SERVICE BULLETIN

M-1067

June 13, 1997

ELECTRONIC CONTROL MODULE (ECM) RECALIBRATION (PRODUCT PROGRAM NO. 5)

Figure 1. Ignition/Light Key Switch

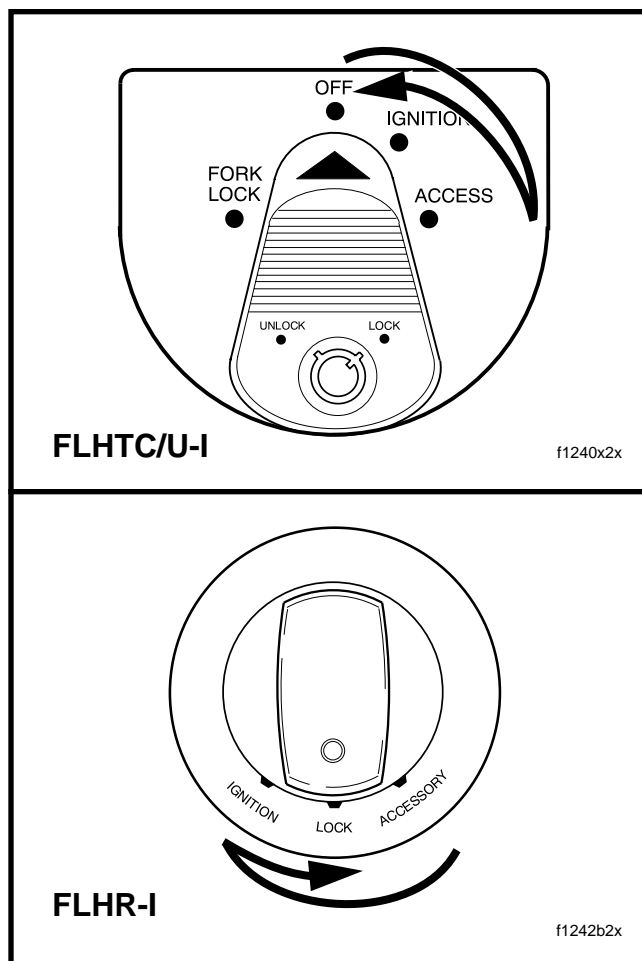
Harley-Davidson has learned that the batteries of 1997 fuel injected vehicles may discharge with the Ignition/Light Key Switch in the OFF (FLHTC/U-I) or LOCK (FLHR-I) position. This condition only occurs when the ECM receives a very brief pulse of battery voltage as a result of the switch being in the IGNITION position momentarily. Such pulses can be received by the ECM as follows:

- The Ignition/Light Key Switch is turned to the ACCESS(ORY) position and then returned to OFF momentarily stopping in the IGNITION position. See upper frame of Figure 1.

- The Ignition/Light Key Switch is turned to the IGNITION position and then rapidly returned to LOCK. This may occur if the operator momentarily overshoots the LOCK position while turning the knob from ACCESS(ORY). See lower frame of Figure 1.

Until the problem is rectified through the appropriate dealer contact, owners also should be advised that the problem can be avoided by leaving the Ignition/Light Key Switch in the IGNITION position at least until the Check Engine Lamp becomes extinguished.

Figure 3. ECM Recalibration Routine

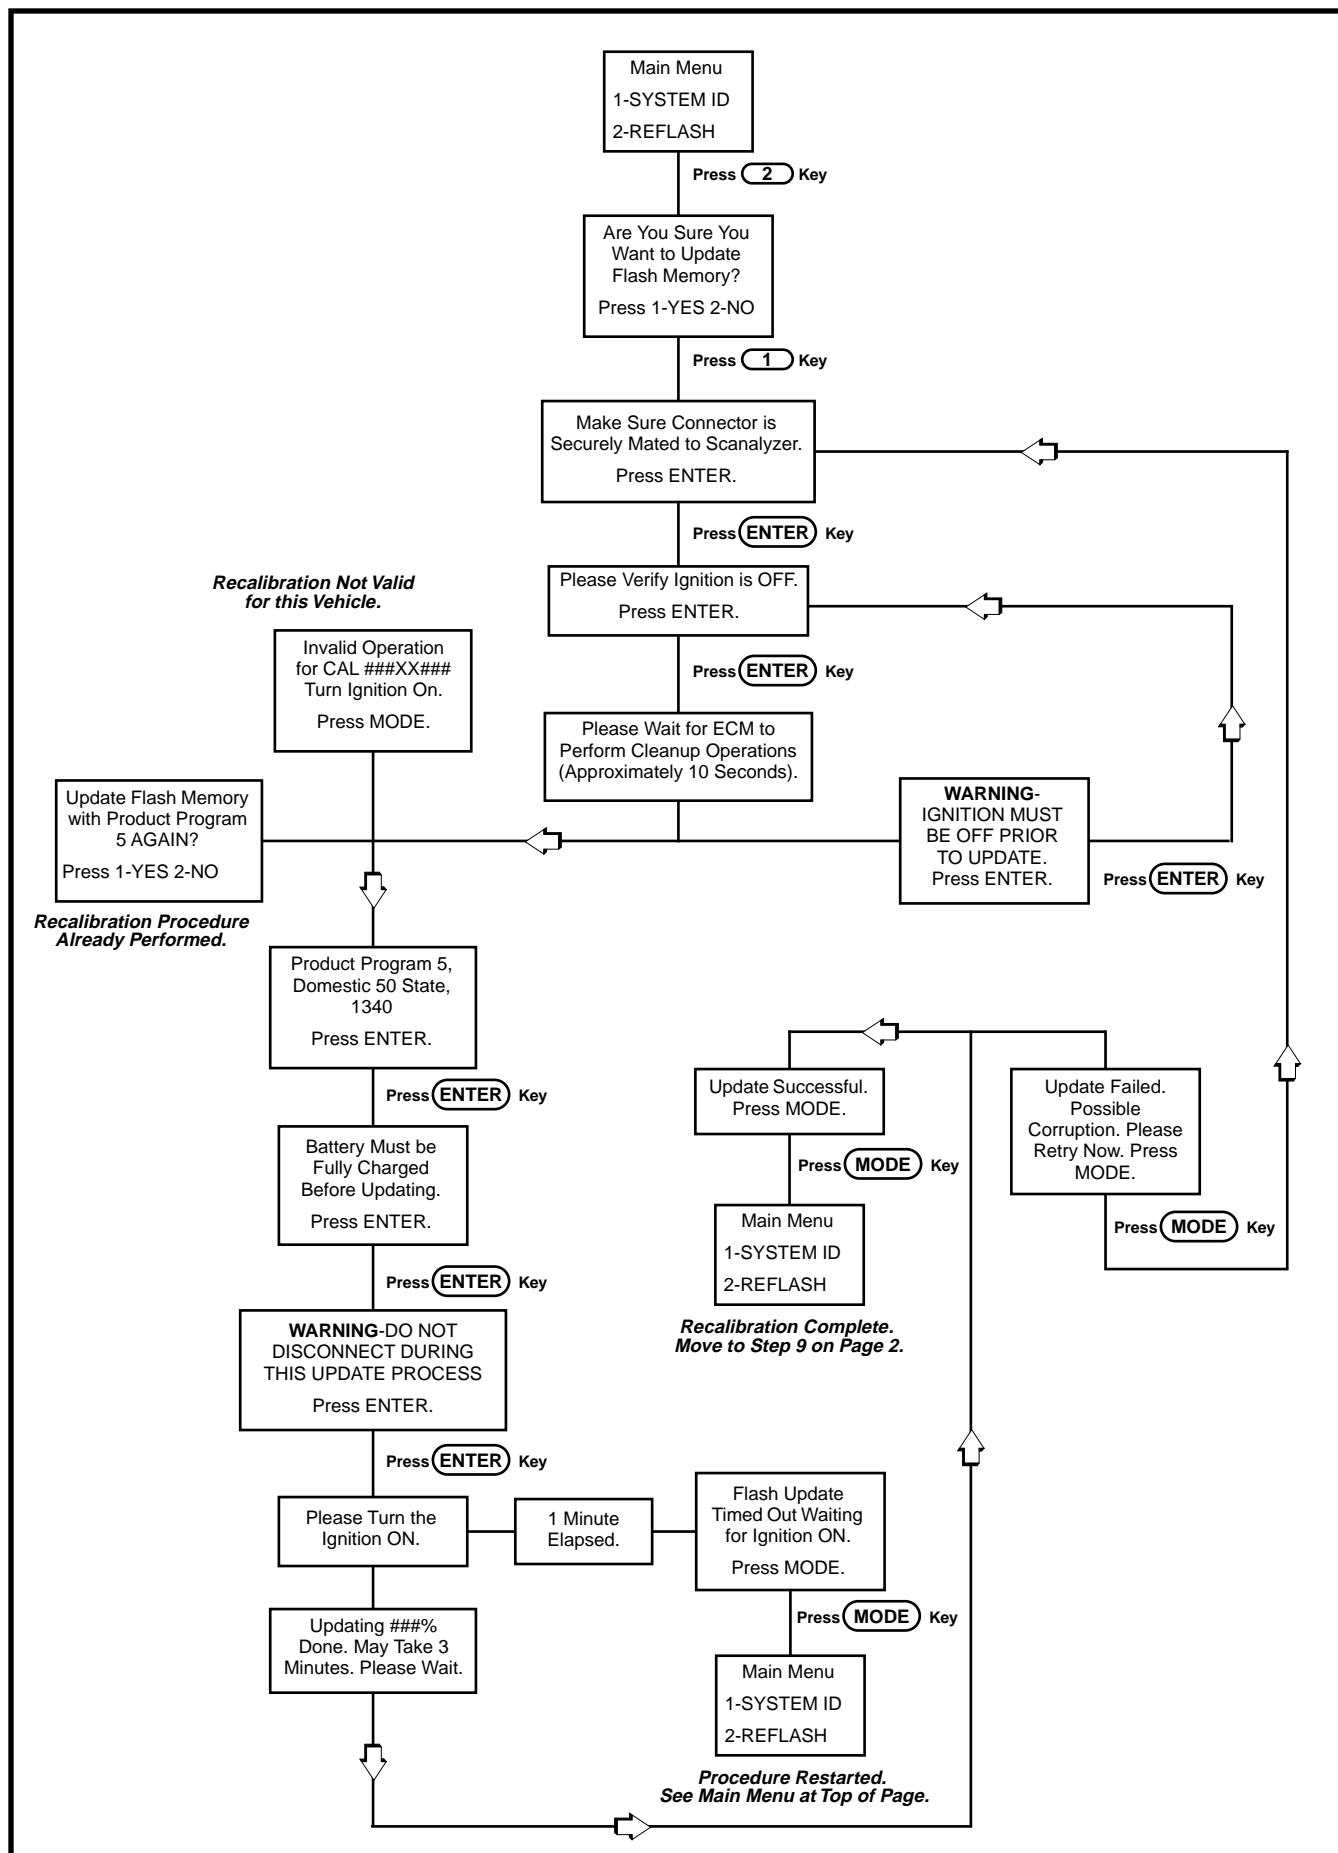
- If the Scanalyzer data display reads "CAL. 220AG338" then the recalibration still needs to be performed. Press the Mode key to return to the Main Menu and then follow the flow chart in Figure 3 to recalibrate the ECM.

9. Upon completion of the recalibration routine, the Scanalyzer returns to the Main Menu. Disconnect the Scanalyzer and turn the Ignition/Light Key Switch to OFF or LOCK. Turn the handlebar mounted Engine Stop Switch to the OFF position.
